Three Mile Island Nuclear Station  
Temporary Change Notice (TCN)

TCN NO. 2-77-030  
(From TCN Log Index)  
Unit No. 2  
Date 2/11/79

1. Procedure 2301-51 Shift & Daily Checks  
No. Title

THREE MILE ISLAND NUCLEAR STATION  
UNIT #2 SURVEILLANCE PROCEDURE 2301-S1  
SHIFT AND DAILY CHECKS

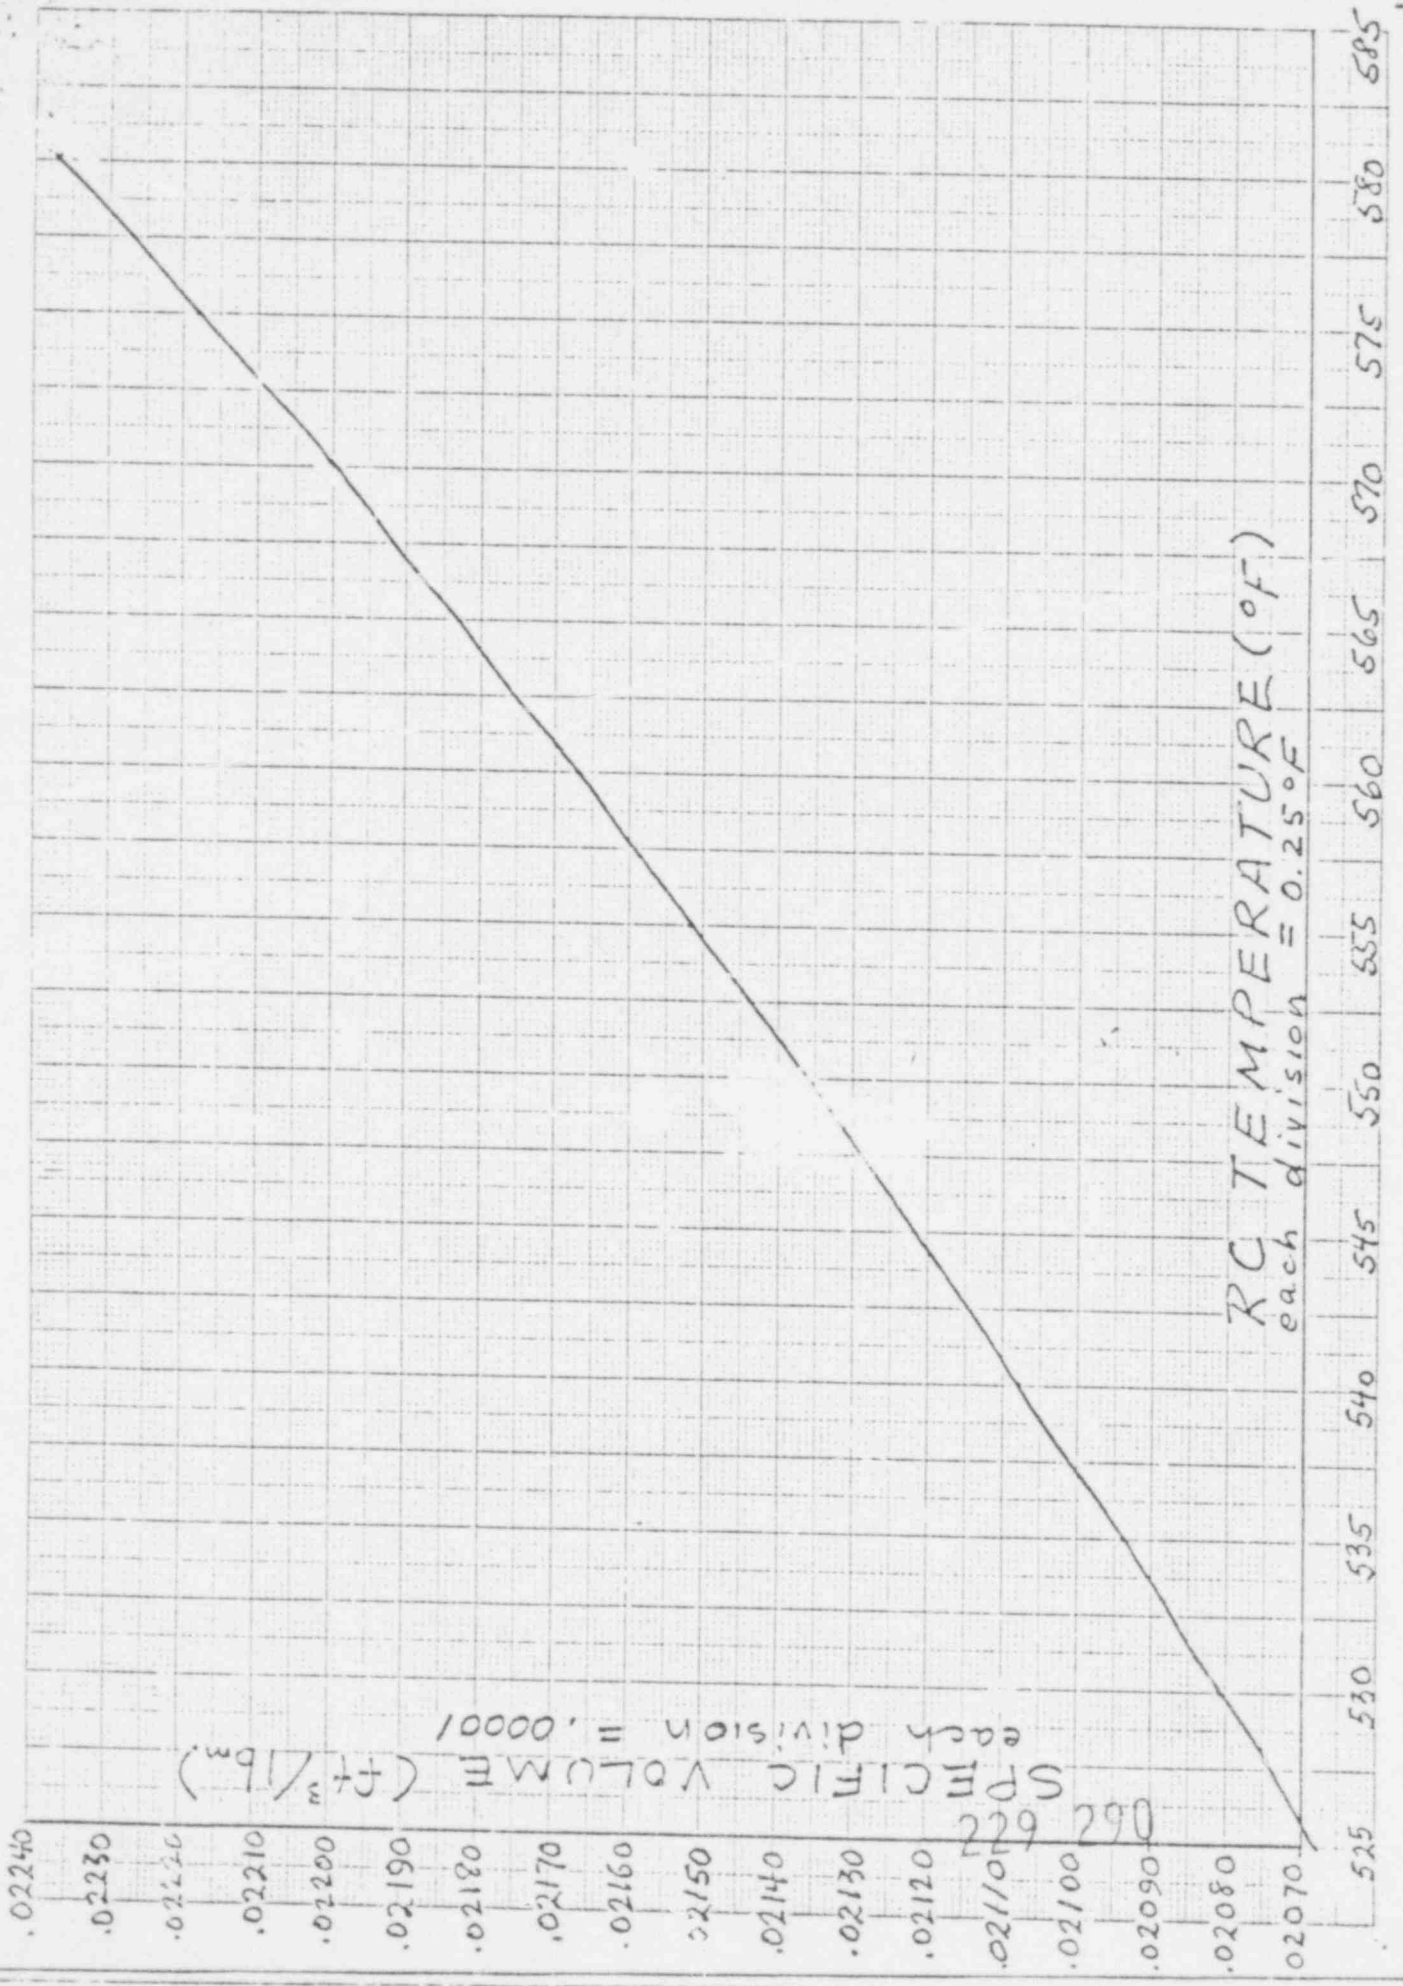
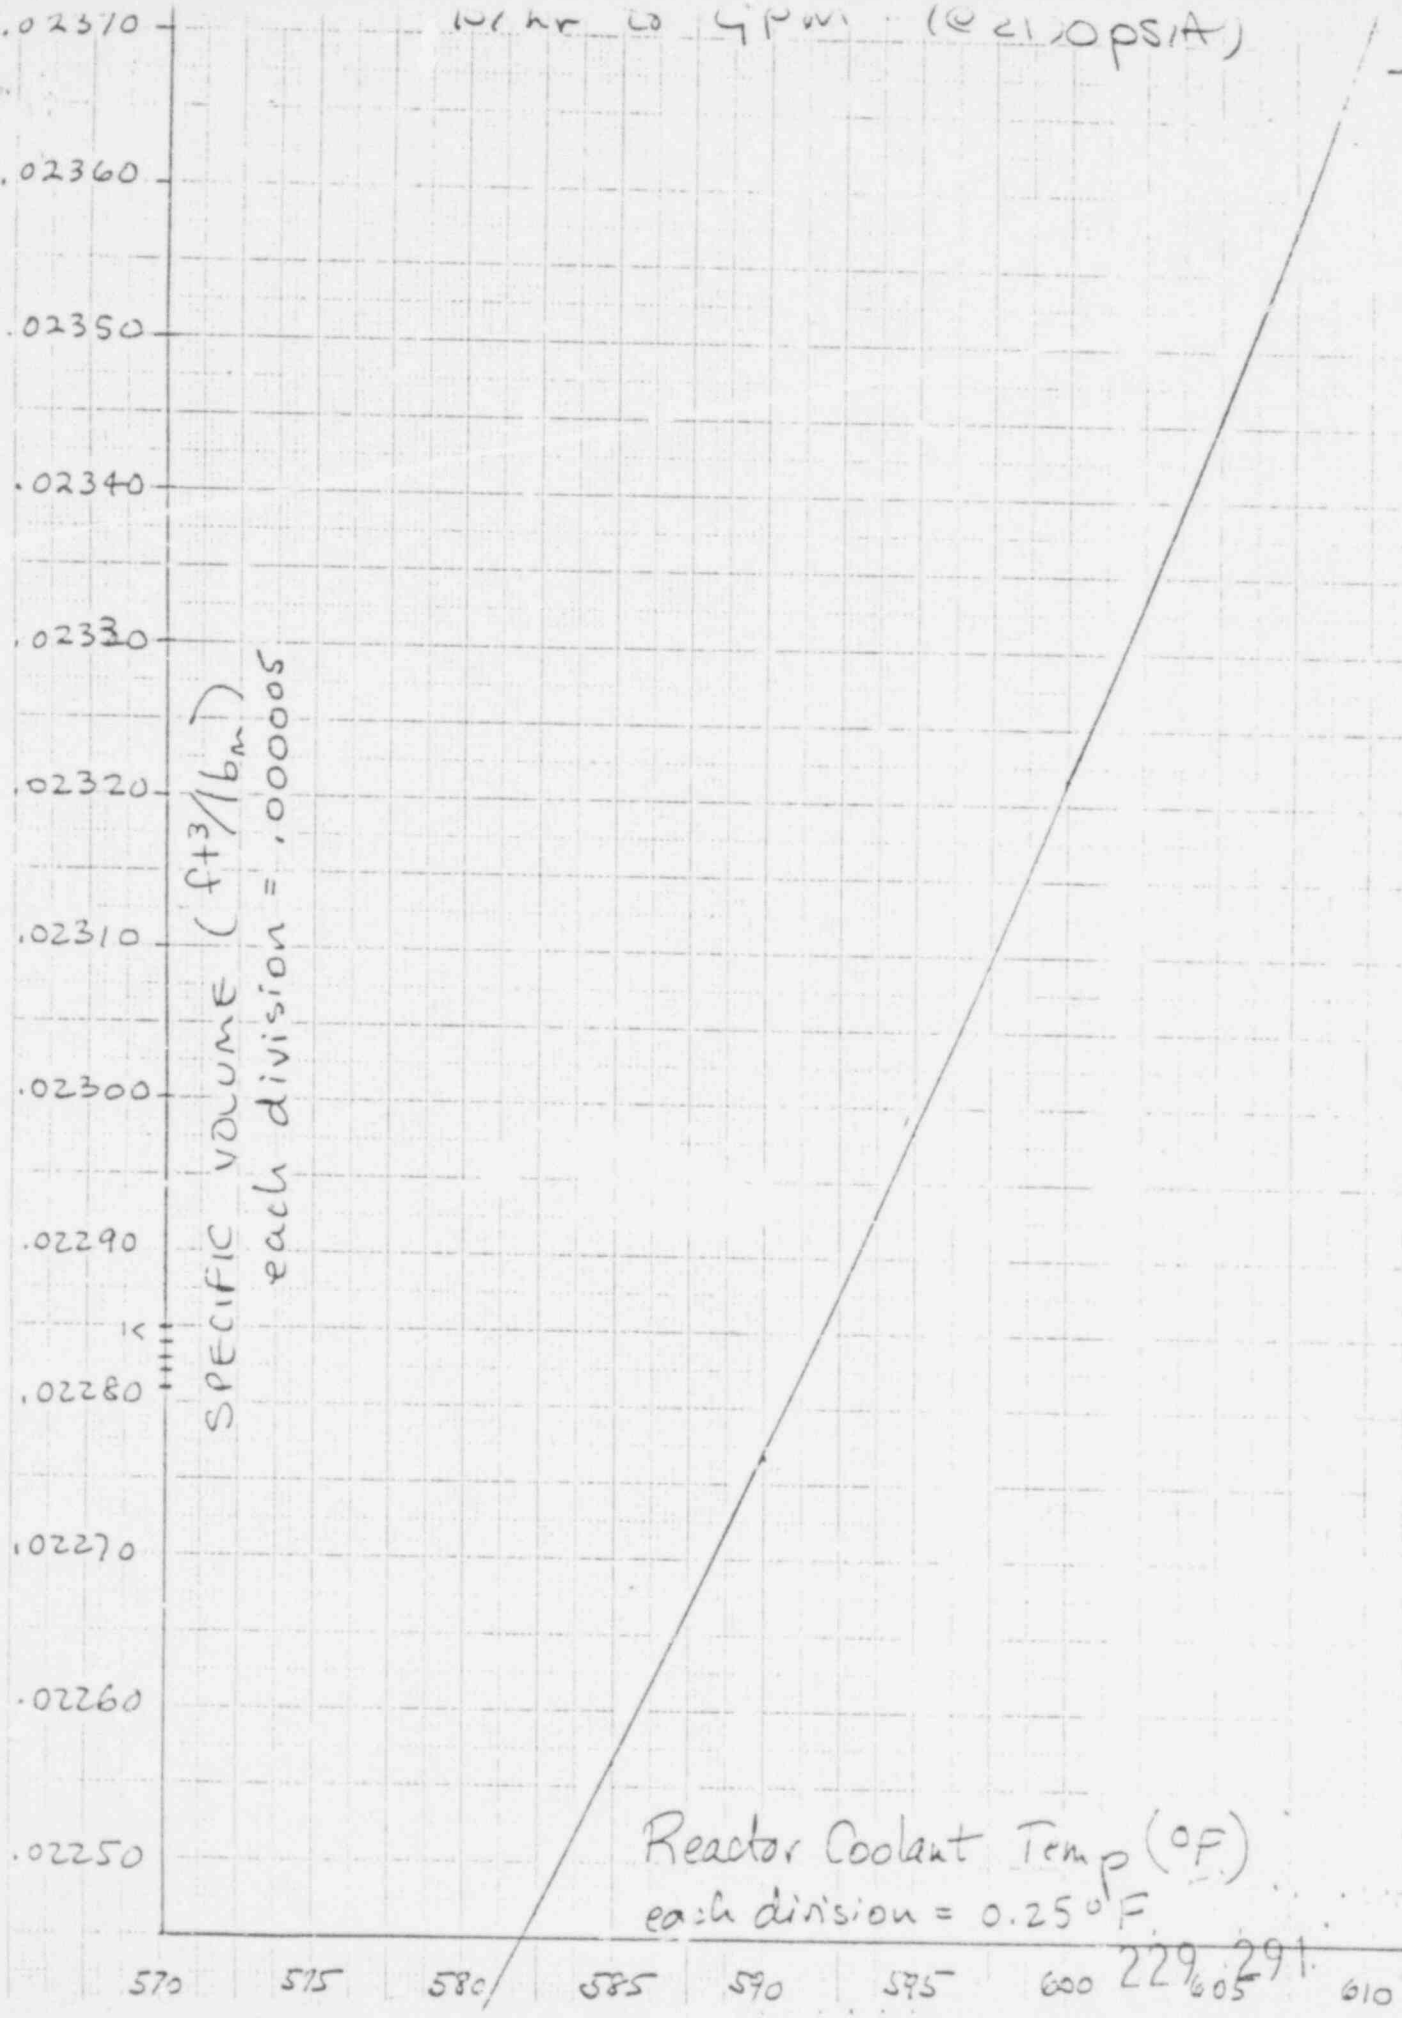
2. Change (Include page numbers, paragraph numbers, and exact wording of change.)  
Page 140 Section 3.2.5 (total flow) from Enclosure 1

3. Reason for Change: Addition of Appendix I & Figure 3 (See Attached)

To incorporate best balance calculation for RCS flow determination

C. Obtain the value for specific volume ( $v$ ) for the average RC Inlet Temp. calculated in step B. See Figur. 3A or 3B.
